H.B. Robinson Steam Electric Plant, Unit No. 2 LAR Proposing to Add an Offsite Circuit to TS 3.8.1 and the Use of Automatic Load Tap Changers

September 7, 2017

H. B. ROBINSON UNIT 2 CAROLINA POWER & LIGHT COMPANY UPDATED FINAL SAFETY ANALYSIS REPORT
ONE LINE DIAGRAM UNIT 2 AUXILIARY DISTRIBUTION SYSTEM
FIGURE 8.1.2-1A REVISION NO. 26

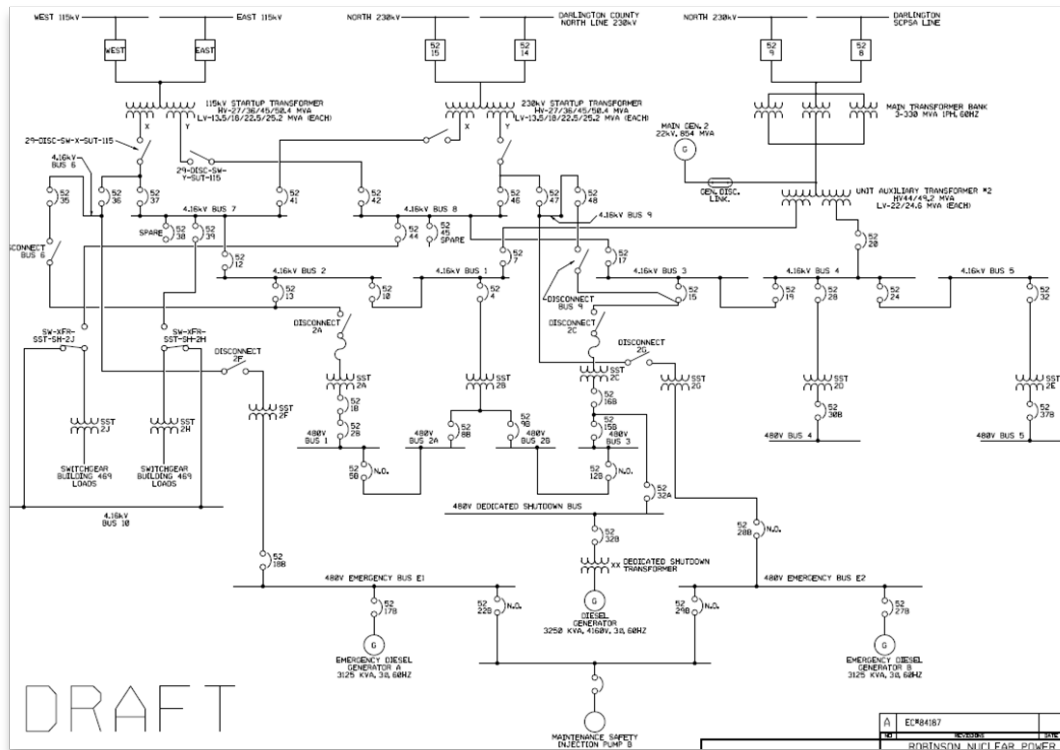
- Big Picture Changes to HBRSEP
 - Provides a second offsite power source.
 - Provides direct feeds to Emergency Buses E1 and E2 from the new replacement 115kV SUT and the new 230kV SUT (Bus E1 is no longer reliant on a Fast Bus Transfer after unit trip).
 - Allows the Energy Control Center to lower minimum required HBRSEP switchyard voltage. The LTCs compensate for this allowance.
 - Provides switchyard breaker controls for each LTC and SUT in the Main Control Room.
- Current Status of project
